THE EFFICIENT RANCH

FAMILY BUILDING CO.

Job Number: 0522-23

S1

FOUNDATION PLAN

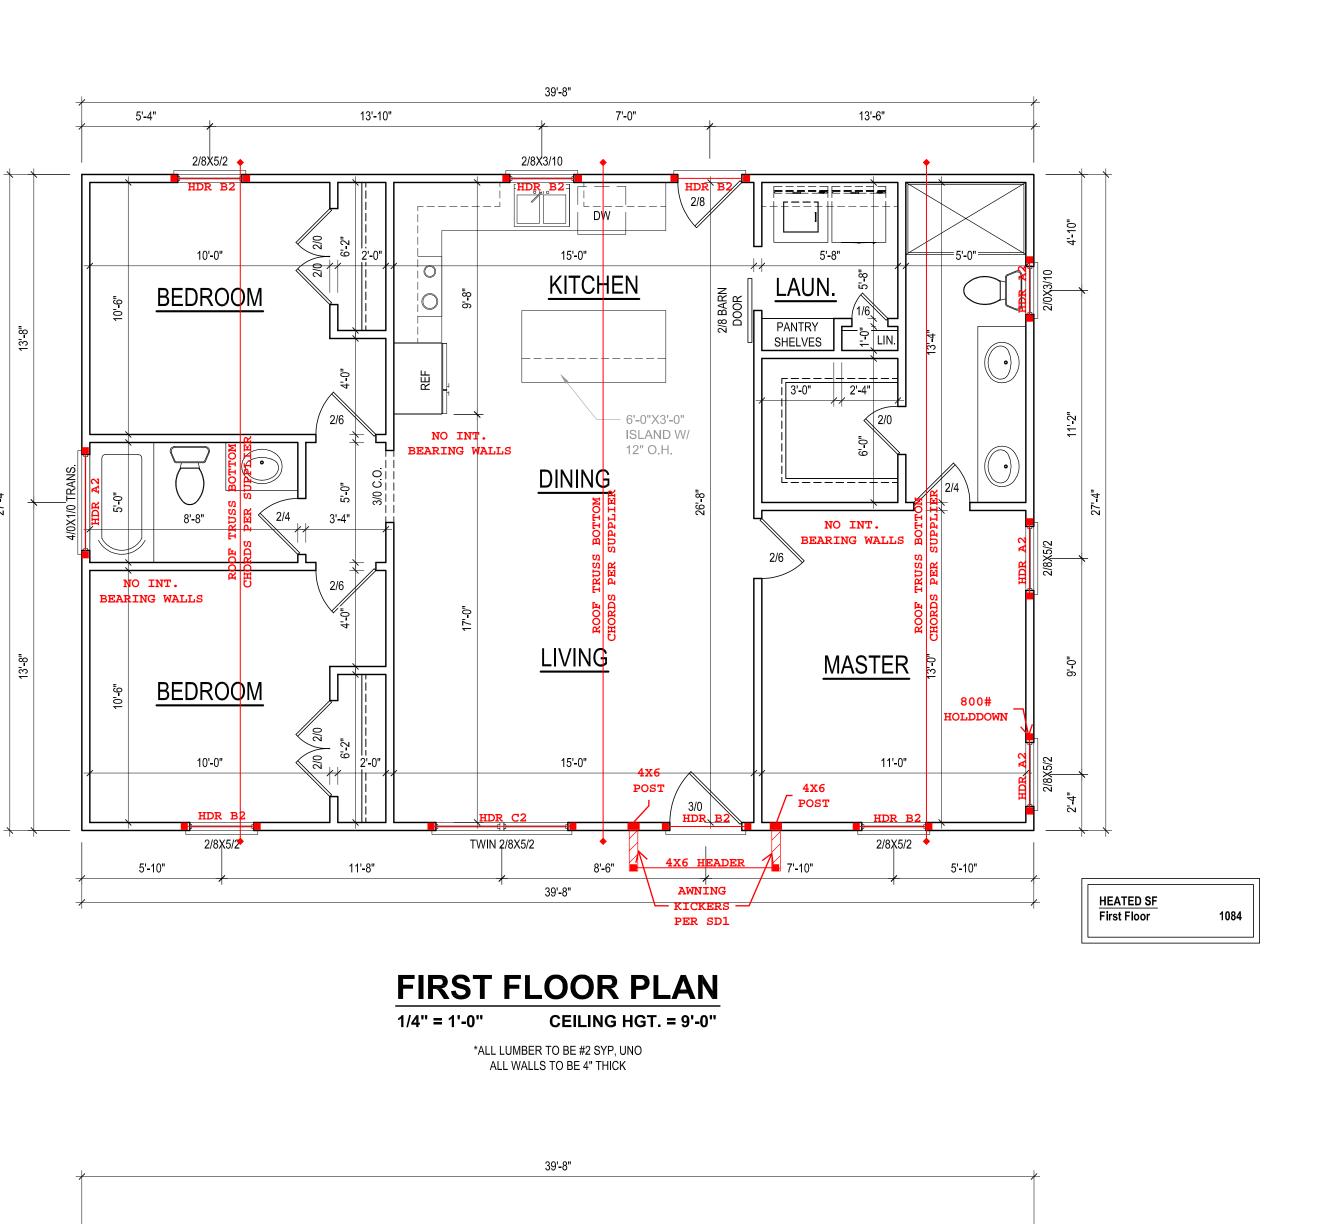
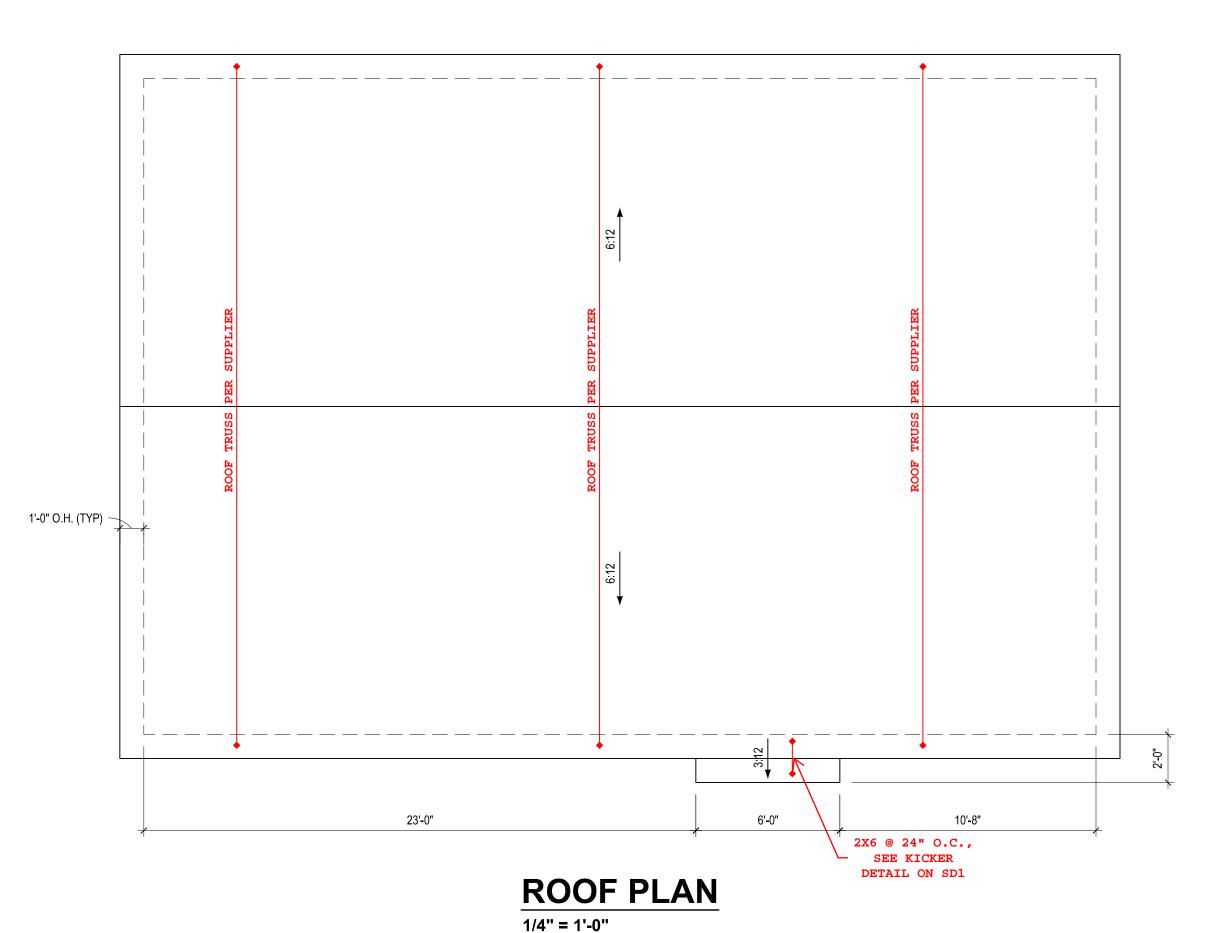
4 CONC SLAB W/ 626 10/10 NWF OR
FFRENCH ON FAIR PLACEMENT

14 CONC SLAB W/ 626 10/10 NWF OR
FFRENCH ON FAIR HASTO SOIL. COT.
12 O'GR 3 ' UNDALANCED

4° CORC SLAD W/ EXS 10/10 WAY OR
FIRMES OVER 6 MLI VANOR RET OVER MIN
4° OF STORE ON FERM IN-SITU SOLL, COT
1.22 ACM WAY ASAP AFTER FLACEBORY
